Manual of ELMB_MB v.6.5.2 modifications for technicians.

Date: 10 Jan 2007

Summary: This document describes the component changes of LVPS ELMB_MB from produced version 6.5 into new version 6.5.2. All mentioned component names and values are referring to the scheme components designed by Ivan Hruska of ELMB_MB version 6.5.

Fig.1: Top side photo of ELMB_MBv6.5. Remove 8x 100hm resistors (R129 – R136 marked in red color), short-cut them by a piece of wire, or put zero ohm resistors (size 1206).

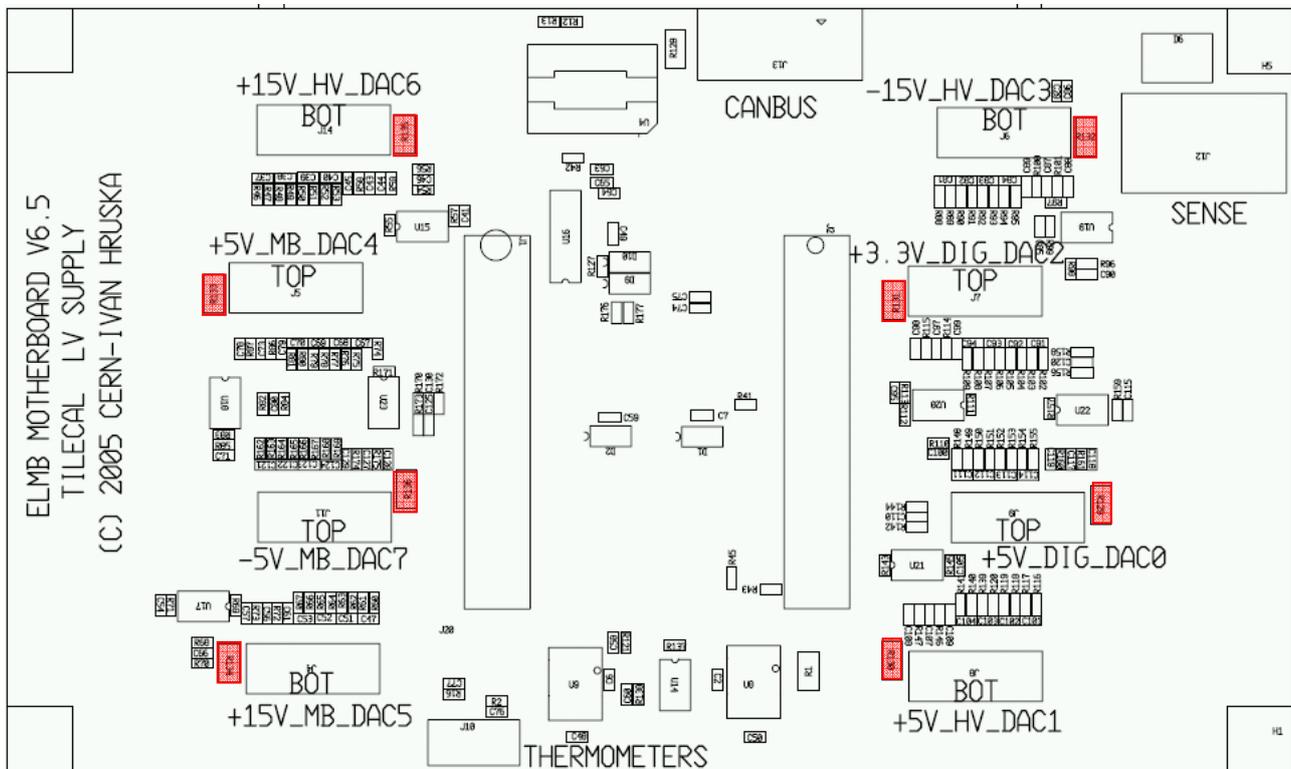
1. Short eight resistors R 129 – 136. Put zero ohm resistors (to minimize Start-up pulse dependency on Vout of the brick).

Fig.2: Top side photo and details of ELMB_MBv6.5. Remove 8x 100nF capacitors: C119, C99, C109, C129, C89, C61, C45, C79, marked in red color (size 0603).

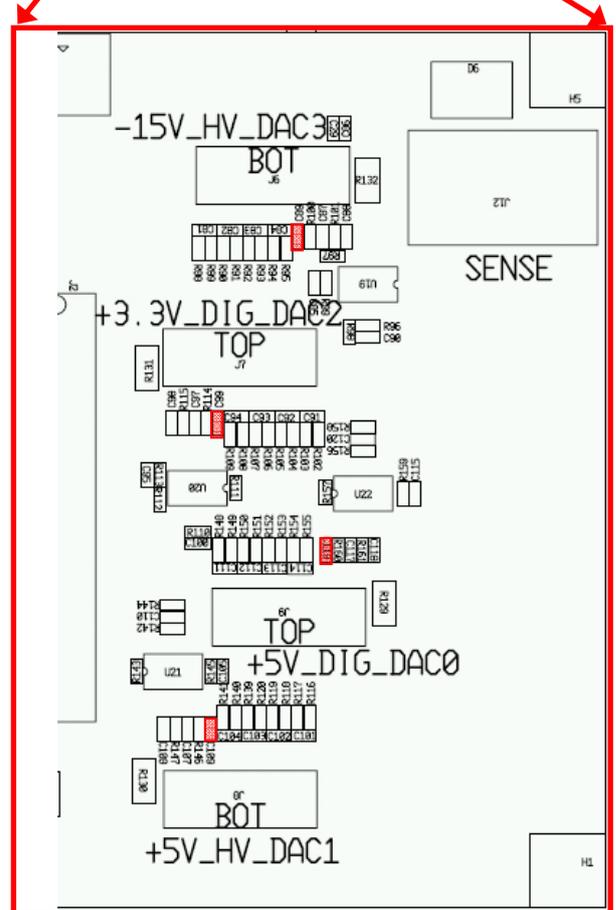
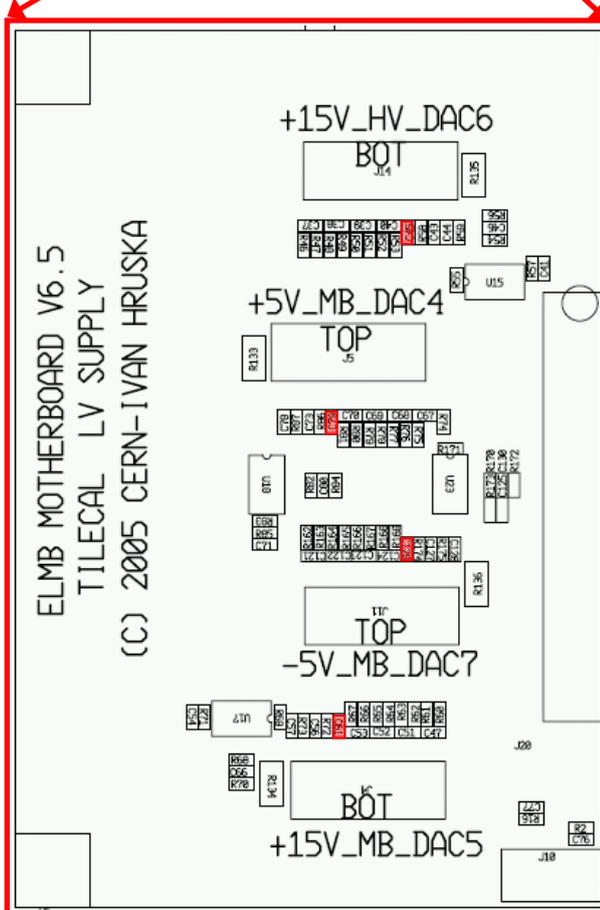
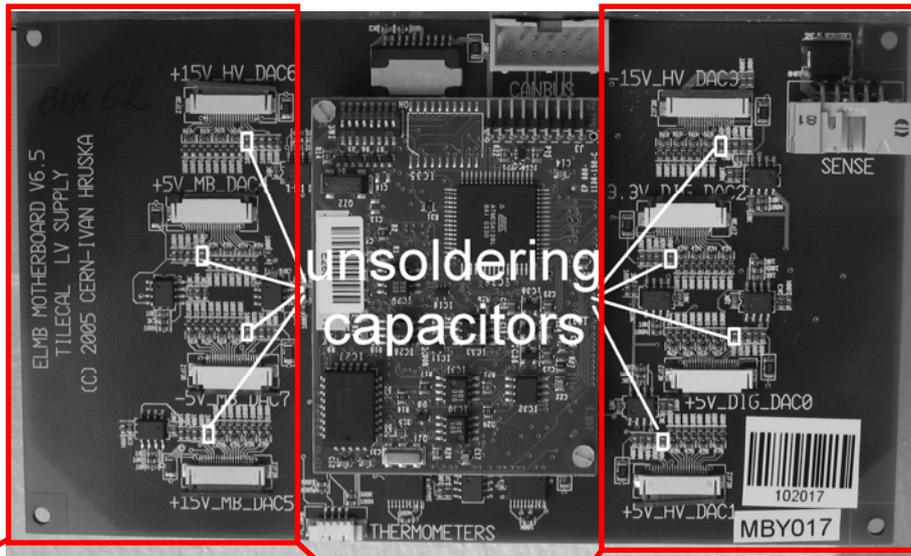
- Remove C119, C99, C109, C129, C89, C61, C45, C79 (size 0603) on top side. Due to unconnected one temperature measurements of each brick the corresponding floating capacitors on the ELMB_MB are removed.

Fig.3: Bottom side photos of ELMB_MBv6.5. Cutting traces on bottom side.

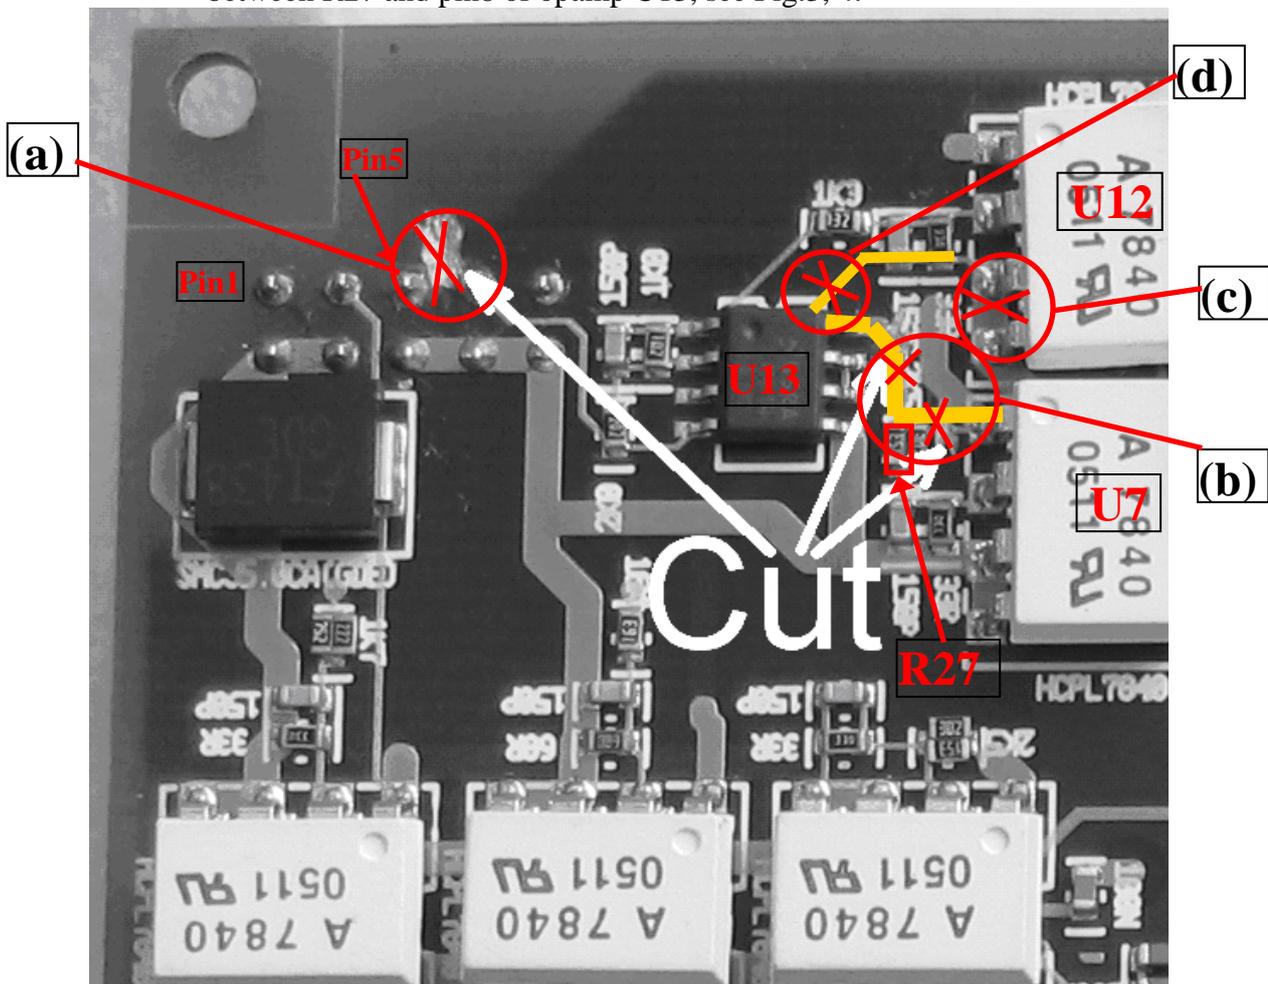
- (a) Cut +5VMB pcb trace from pin5 on connector J12 on the ELMB_MB bottom side, see Fig.3. The pcb trace is under the surface level, so a milling cutter has to be used.
- (b) Cut two traces, between R27 and pin1 of U7 isolation amplifier, and pcb path between R27 and pin8 of opamp U13, see Fig.3, 4.

Fig.4: Bottom side component placement detail of ELMB_MBv6.5, as shown as a photo in Fig 3. Marked components related to procedure 3 a – d are in red color: U13, C22, R38, R27, U12, and U7.

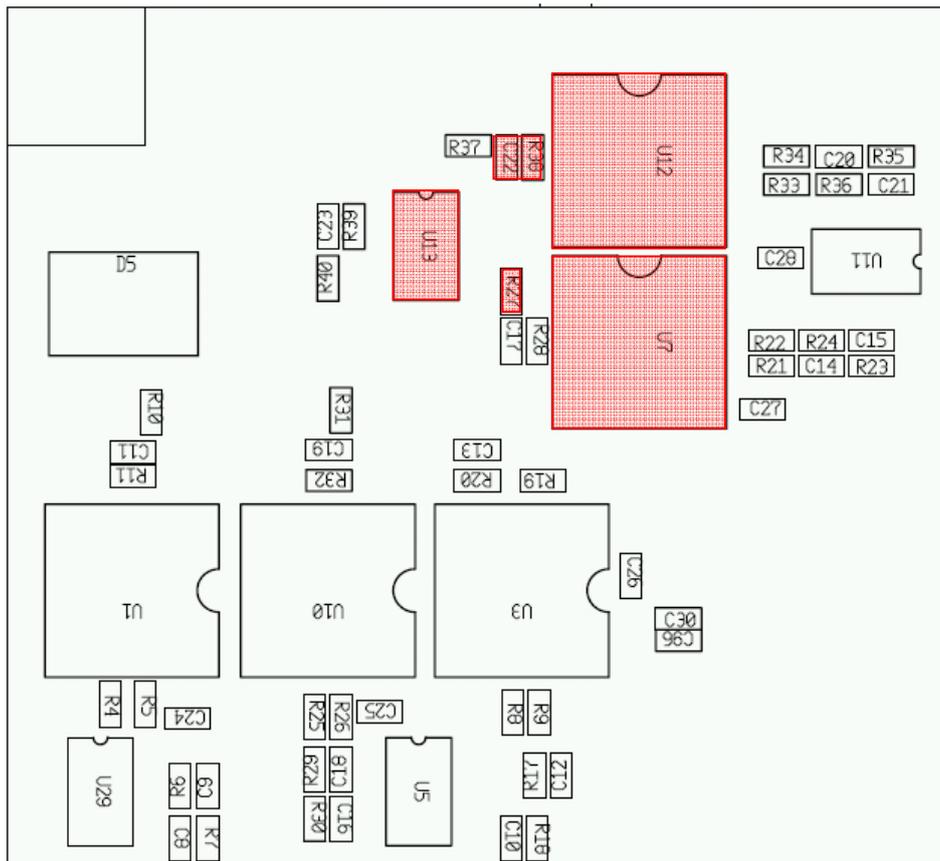
- (c) Cut trace between pin3 and pin4 of U12 isolation amplifier, see Fig.3, 4.
- (d) Cut trace going to gnd from C22 and R38, see Fig.3, 4.

Fig.5. Measuring points of successful cuts 3 a - d.

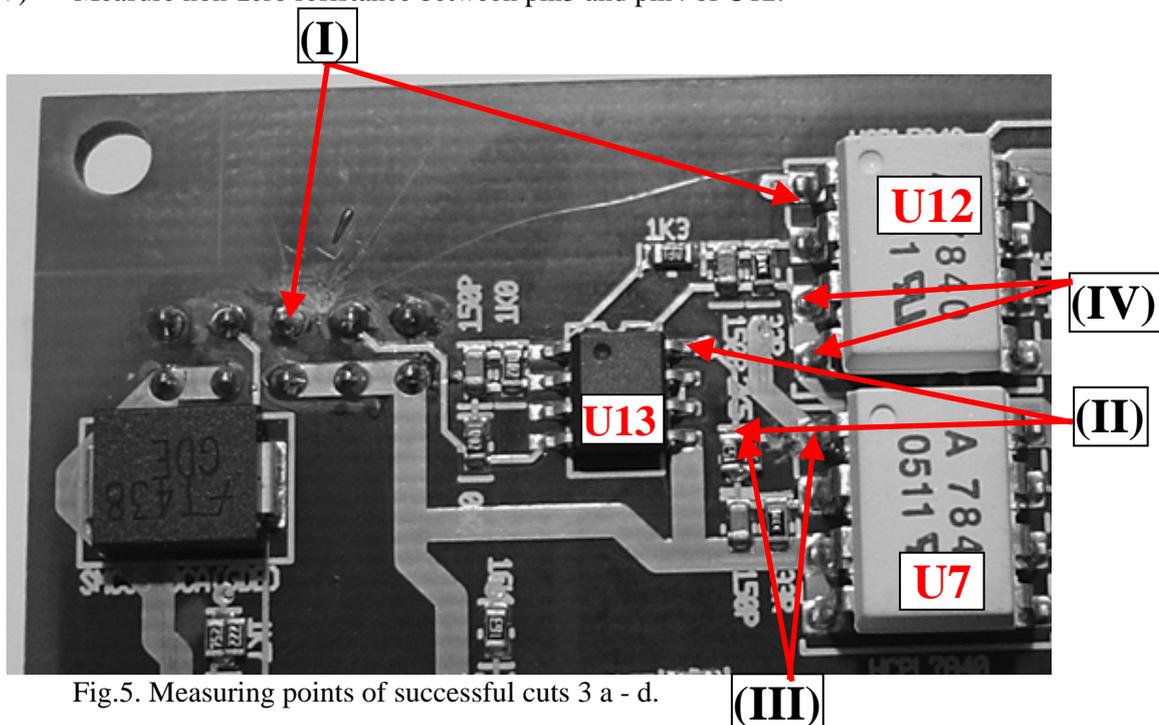
Verify cut traces (3 a - d) by measuring 3 points, see Fig.5.

- (I) Check non-zero resistance between pin5 (J12) and pin1 of U12.
- (II) Measure non-zero resistance between pin8 of U13 and R27.
- (III) Measure non-zero resistance between R27 and pin1 of U7.
- (IV) Measure non-zero resistance between pin3 and pin4 of U12.

Fig.6. Unsoldered components from bottom side ELMB_MBv6.5 related to point 3-e.

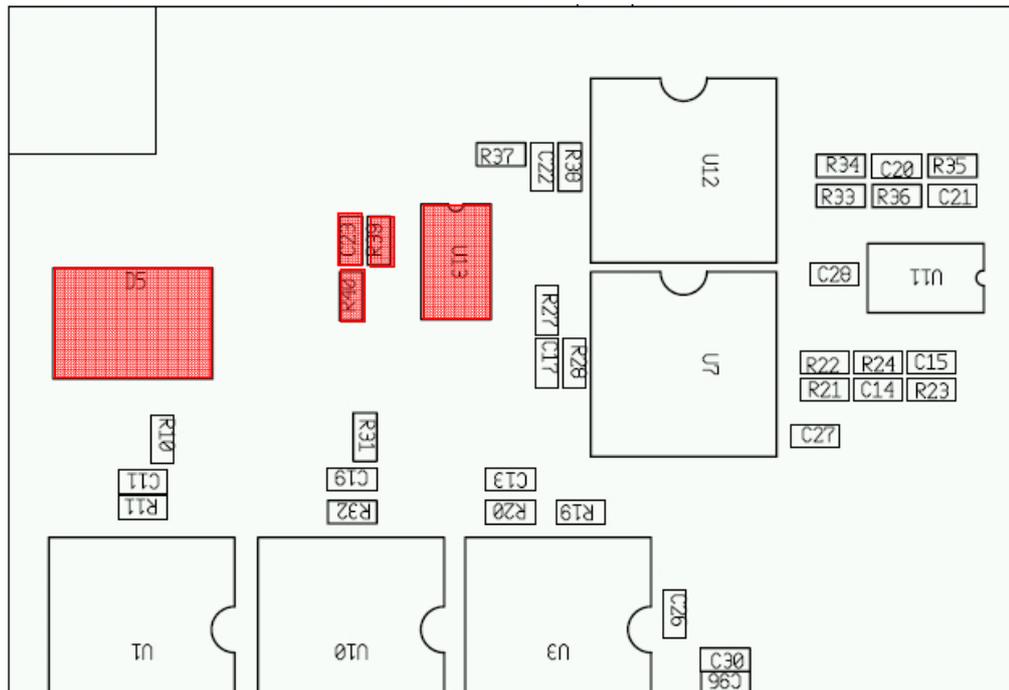
- (e) Unsolder opamp U13, resistor R39, R40, and capacitor C23. Unsolder also Transil D5, see Fig.6.

Fig.7. Resistor dividers to be changed on ELMB_MB bottom side.

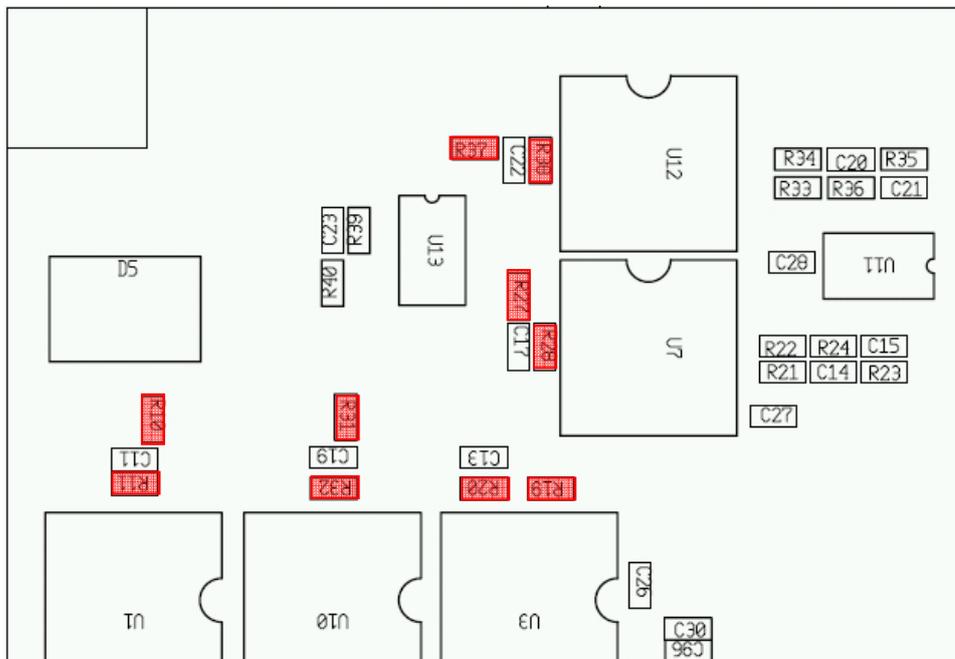
- (f) Nominal resistor values of ELMB_MB input sense line dividers have been changed, see scheme on page 8 and Fig.11. New resistor values are:

These modifications were applied to reduce the influence of 1kOhm (1%) separating resistors (inside Drawer) on the ELMB_MB sense lines measurements. Resistor R37 is soldered

R11, R20, R28, R32, R38 = 200 ohm

R10 = 10k,

R19 = 16k,

R27 = 15k,

R31 = 47k,

Fig.8. Detail picture how to solder resistor R37 in diagonal to the opposite end of C22 capacitor.

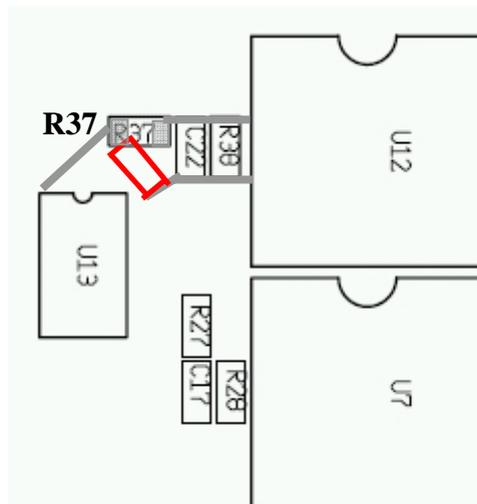
R37 = 15k, soldered in diagonal to other end of C22 capacitor, see detail in Fig 8.

Fig.9. Wire connections on bottom side 3-g, h, i, j.

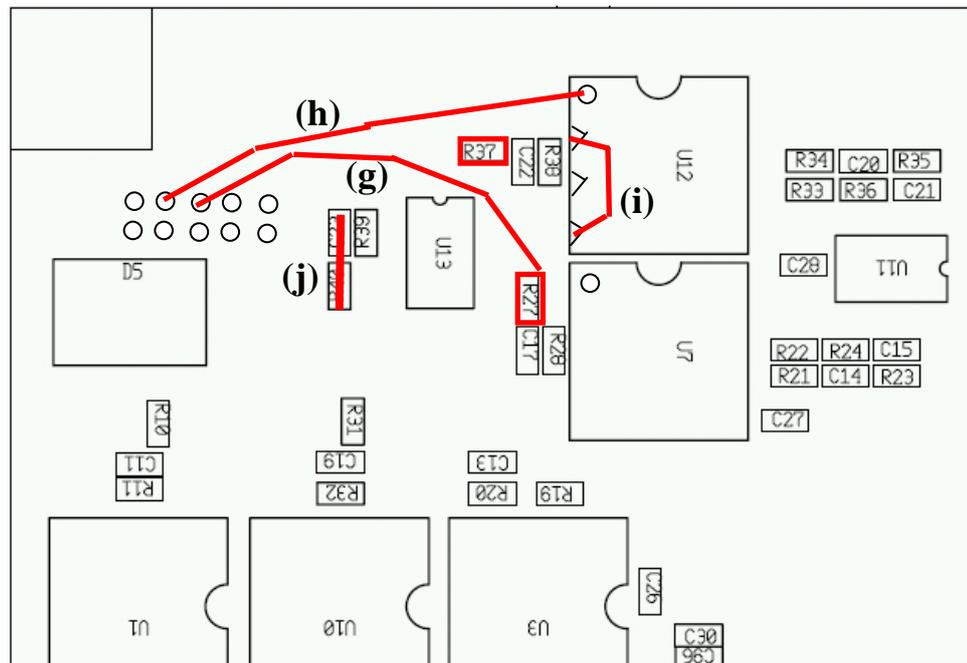
- (g) Resistor R27 (part of +5VMB sense line divider) connect directly to pin5 of J12 connector by a 30mm piece of wire, see Fig.9.

- (h) Connect pin3 of J12 with pin1 of U12 by using a wire, see Fig.9. This operation will connect +5V DIG with power supplies of all five isolation amplifiers (HCP7840).
- (i) Make a short connection between pin4 and pin 2 of U12, see Fig.9.
- (j) Connect resistor R37 directly to pin7 of the connector J12 (-5VMB sense lines) by means of short-cut through unsoldered components C23, R40, see Fig.9. Verify good connection between pin7 of J12 and resistor R37.
- (k) Solder ceramic capacitors 10uF (size 1210) between pin2 and pin3 of all isolation amplifiers on bottom side of U1, U3, U7, U10, U12, to increase the nominal filtering capacitor values of C11, C13, C17, C19, C22, see Fig.10.

Fig.10. Ceramic capacitors on U1, U3, U7, U10, U12, and capacitor 68uF/20V in place of D5 transil.

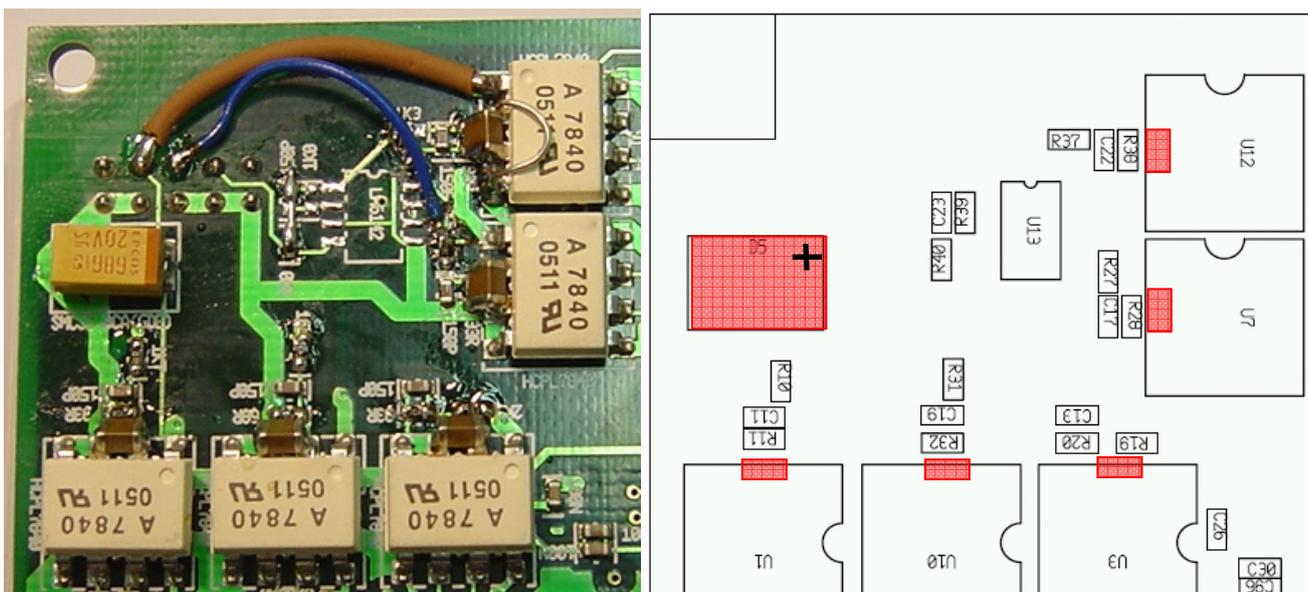
- (l) Solder tantalum capacitor 68uF/20V in the place of removed transil diode D5. Positive polarity has to be towards pin3 of J12 connector, see Fig.10.

Fig.11: Part of the MB_ELMB V6.5 schematic documentation. Changes of sense line optocouplers powering do +5VDIG line, changing of resistor dividers for all sense lines. All changes are drawn in red color.

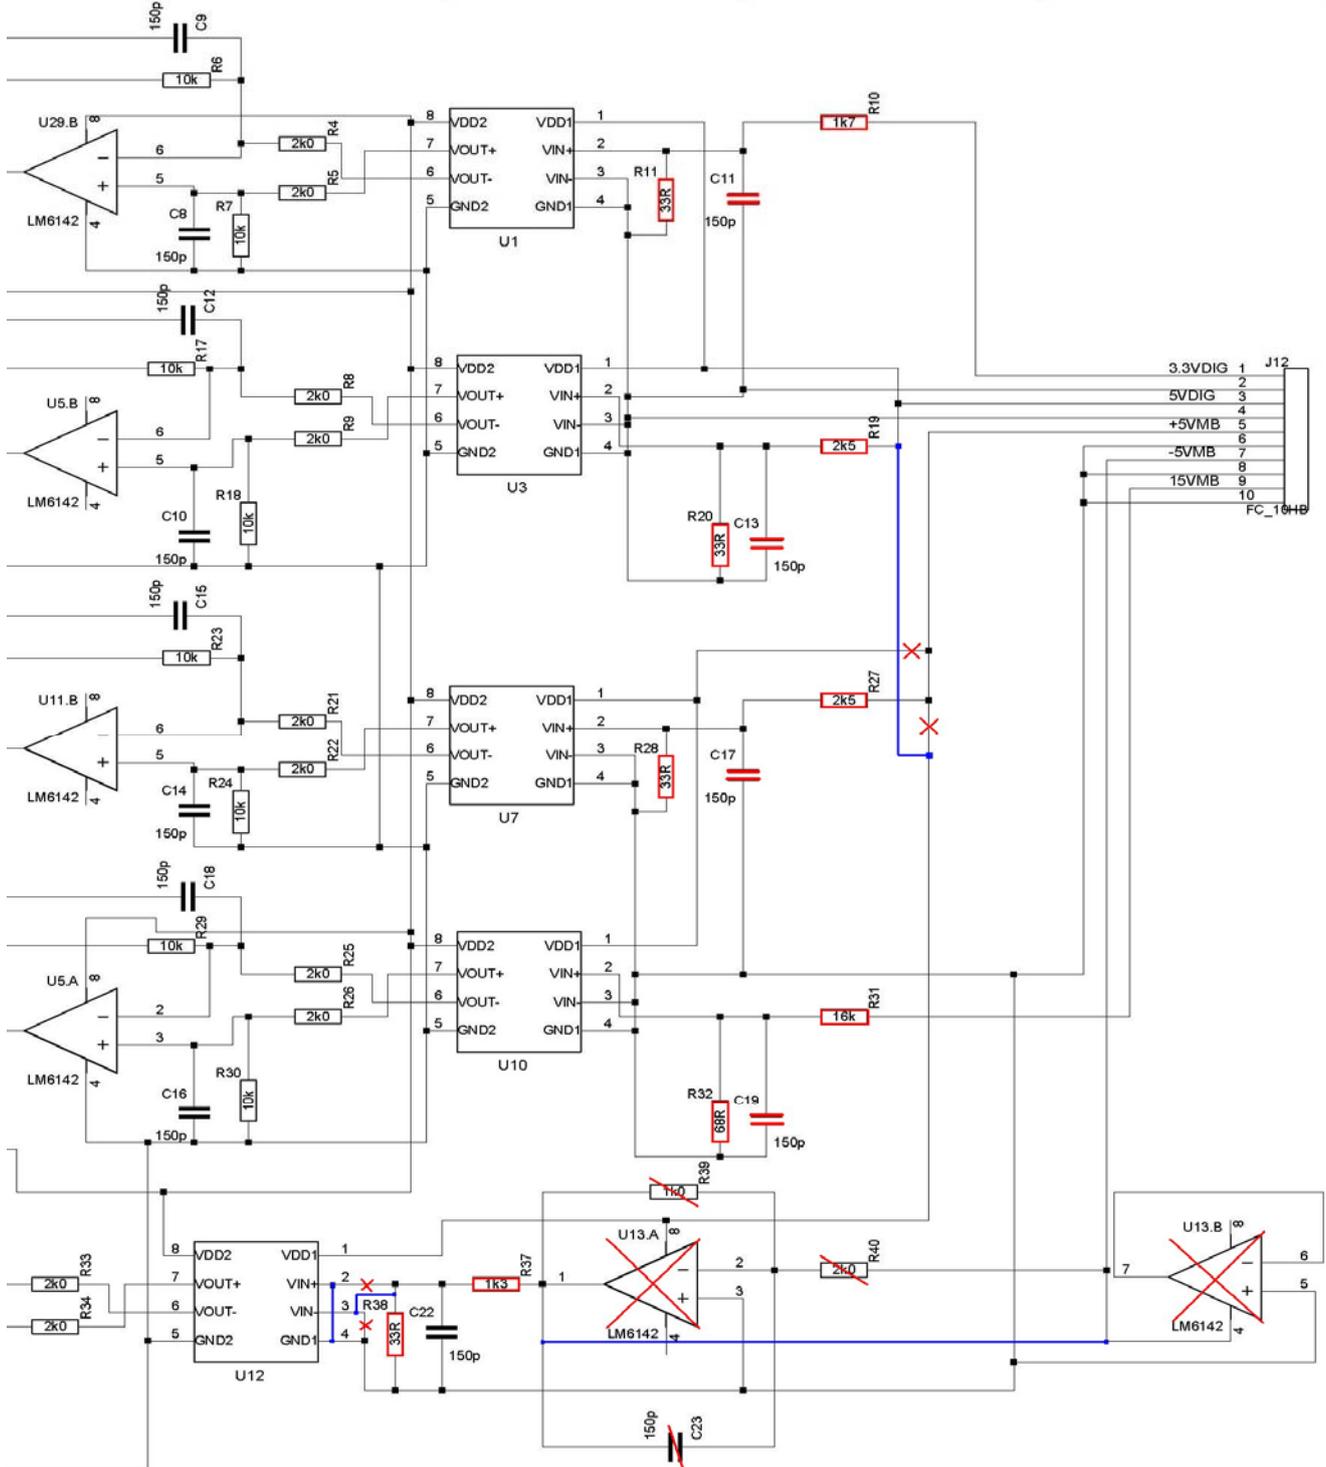
3. **Improvement of five drawer sense line measurements: +3VDIG, +5VDIG, -5VMB, +5VMB, +15VMB. See further ELMB_MB scheme detail on page 8, Fig.11 for more information.**

Appendix1: Sense line part with isolation amplifiers of the ELMB_MBv6.5 electrical scheme discussed in part 3.
